7.2 Reactor Protection (Trip) System (RPS)—Instrumentation and Controls

The information in this section of the reference ABWR DCD, including all subsections, tables and figures, is incorporated by reference with the following departures and supplements.

STD DEP T1 2.3-1 (Table 7.2-1, 7.2-2, Figures 7.2-2, 7.2-6, 7.2-9, 7.2-10)

Figure 7.2-2 Reactor Protection System Equipment Arrangement (From Sensors Through Trip Actuators)

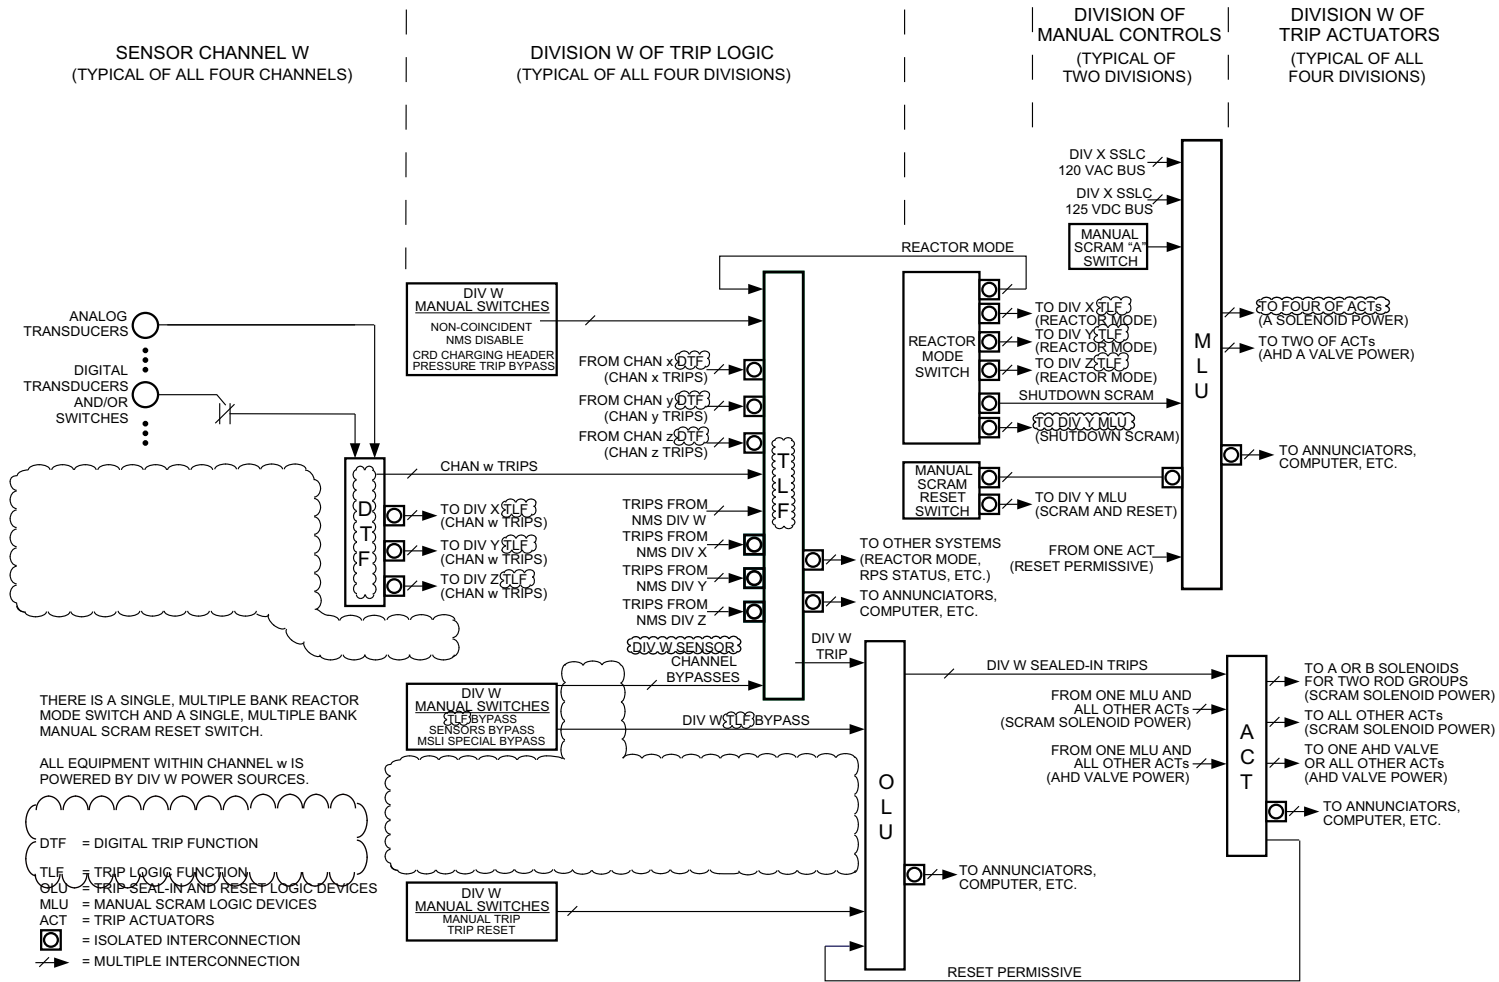
STD DEP T1 3.4-1 (Figures 7.2-2, 7.2-9, 7.2-10)

The RPS equipment is divided into four redundant divisions of sensor (instrument) channels, trip logics and trip actuators, and two divisions of manual scram controls and scram logic circuitry. The sensor channels, divisions of trip logics, divisions of trip actuators and associated portions of the divisions of scram logic circuitry together constitute the RPS scram and air header dump (backup scram) automatic initiation logic. The divisions of manual scram controls and associated portions of the divisions of scram logic circuitry together constitute the RPS scram and air header dump manual initiation logic. The automatic and manual scram initiation logics are independent of each other. RPS equipment arrangement is shown in Figure 7.2-2.

Four independent sensor channels monitor the various process variables listed in Subsection 7.2.1.1.4.2. The redundant sensor devices are separated so that no single failure can prevent a scram. The arrangement of RPS sensors mounted in local racks is shown in Figure 7.2-2. Locations for local RPS racks and panels are shown on the instrument location drawings provided in Section 1.7. ~~Divisional separation is also applied to the Essential Multiplexing System (EMS) D which provides data highways for the sensor input to the logic units. Physically separated cabinets are provided for the four scram logics. Fiber optic cable routing from remote multiplexing units (RMUs) remote digital logic controllers to control room equipment is shown in raceway plans provided by reference in Section 1.7.~~ The criteria for separation of sensing lines and sensors are discussed in Section 7.1.

Figure 7.2-6 Division 1 Trip Logic

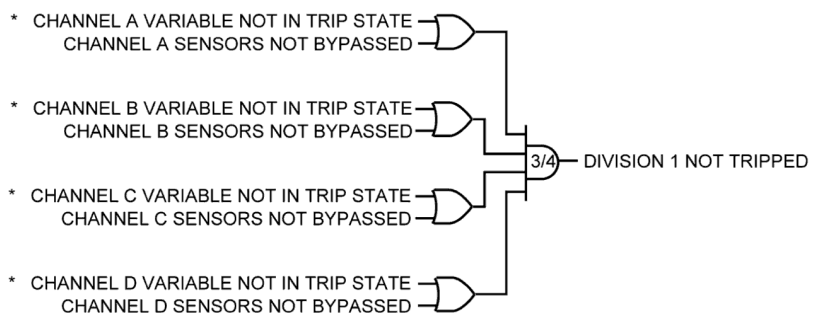
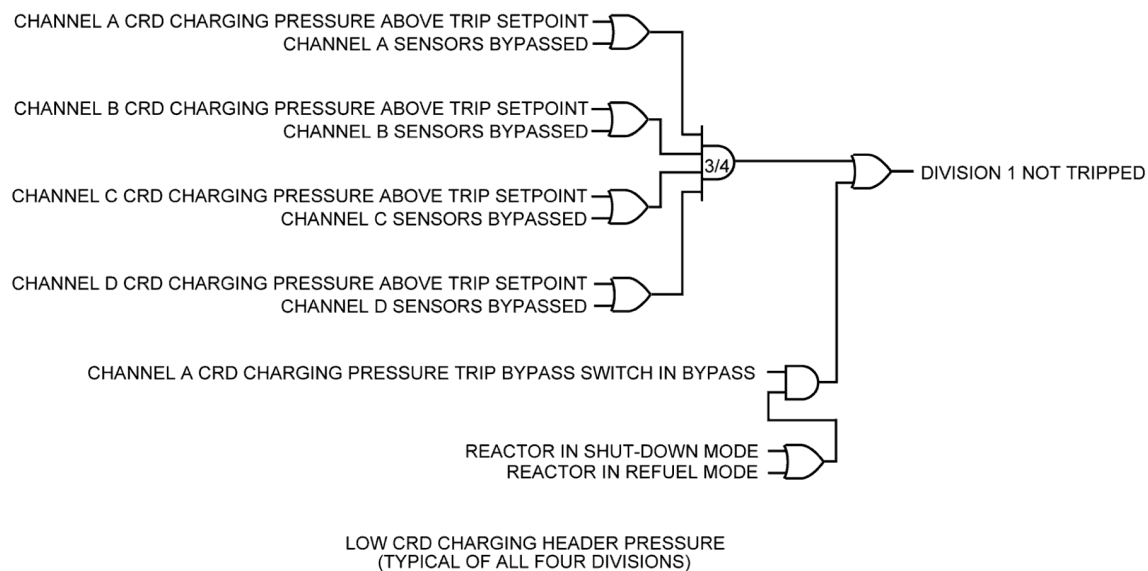
(2) Nuclear Boiler System (NBS) (Figure 7.2-6)

(3) Control Rod Drive (CRD) System (Figure 7.2-6)

~~High Main Steamline Radiation Trip (Figure 7.2-6)~~

~~A high main steamline radiation trip will occur in each division of trip logic when a main steamline radiation trip condition exists in any two or more unbypassed sensor channels. There are no operating bypasses associated with this trip function.~~
